Applicable to Eaton's Carter brand Model 60600, 60700, 61525, 64800, & 64900 hydrant couplers and Model 44665 & 47245 coupler lower half assemblies

***Note part number correction in last paragraph, page 2**

API/EI Bulletin 1584 2nd and 3rd Edition Couplers Now Available

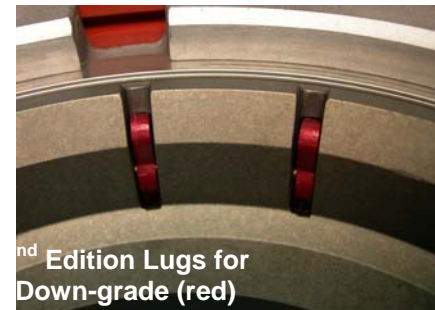
These hydrant coupler lower halves will be manufactured with **RED** locking lugs (part number 200688) and will also be **RED** tagged to notify the end-user that the couplers only meet the requirements of API/EI Bulletin 1584, 2nd edition.
